AN COIMISIÚN PLEANÁLA
LDG- 030901-25
ACP- _____
19 JUN 2025
Fee: € 270.00 Type: CD
Time: _____ By: Post

Reference: LDR Planning application number 25/04551, at Mountain Road, Carrigaline for Bridgewater Homes Ltd, to Cork County Council. Conditional Permission granted on 26/5/2025.

Planning Application Reference Number: 254551 Applicant: Bridgemount Homes Ltd.,
Description of Development: Large scale Residential Development.
Location: Mountain Road, Carrigaline.

Figure 10-5. Surface Waterbodies Within 2.0km of the Site

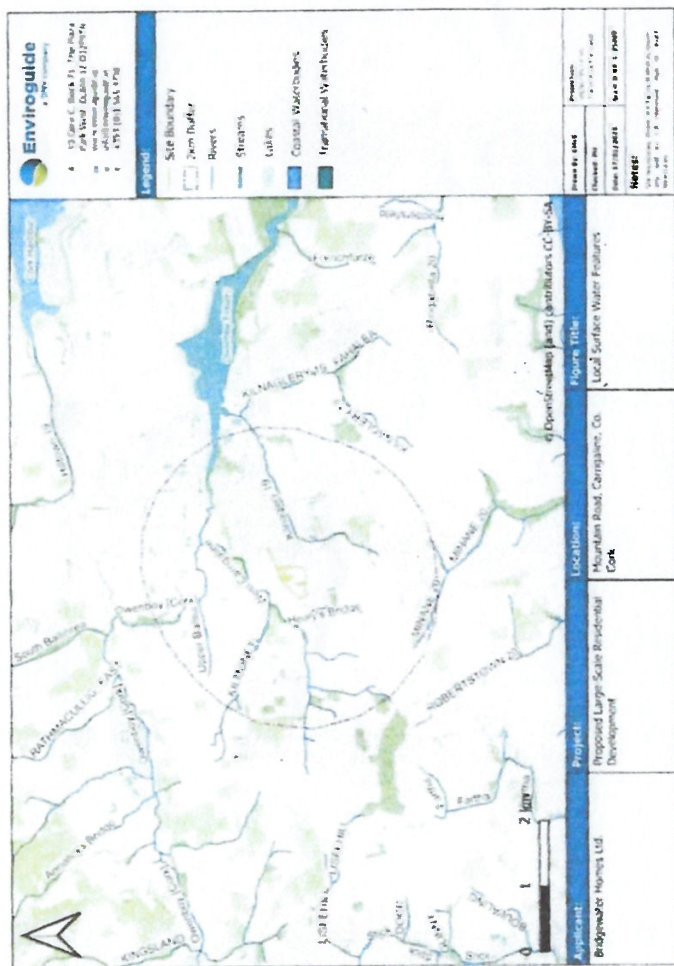
There is an existing 300mm diameter surface water pipe to the north of the site, crossing Mountain Road, and eventually discharges into an existing stream running along Forest Road.
